ORIGINATION FORM

Proposed Revisions to a Standard Plans Index
(Please provide all information — Incomplete forms will be returned)

Index Number: 455-124

Index Title: 24" CFRP & SS Prestressed Concrete Piles

ALTERNATE STRAND PATTERNS

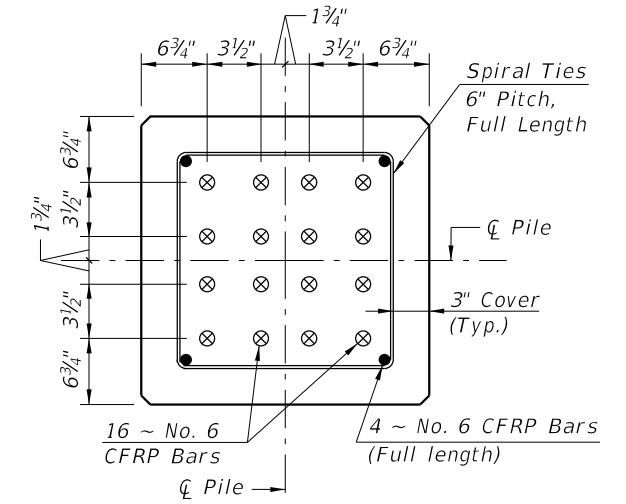
Sheet 1: Changed 0.5" CFRP strand layout; Sheet 2: Added 0.6" HSSS strand

16 ~ 0.6" Ø, CFRP 7-Strand, at 42 kips
~~16 ~ 1/2" Ø, CFRP Single-Strand, at 41 kips~~

STRAND PATTERN

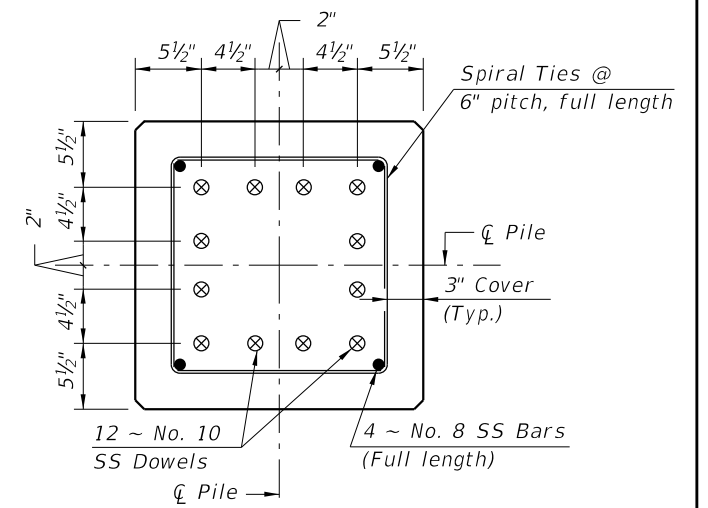
28 ~ 1/2" Ø, HSSS at 26 kips
20~ .06" Ø, HSSS at 35 kips
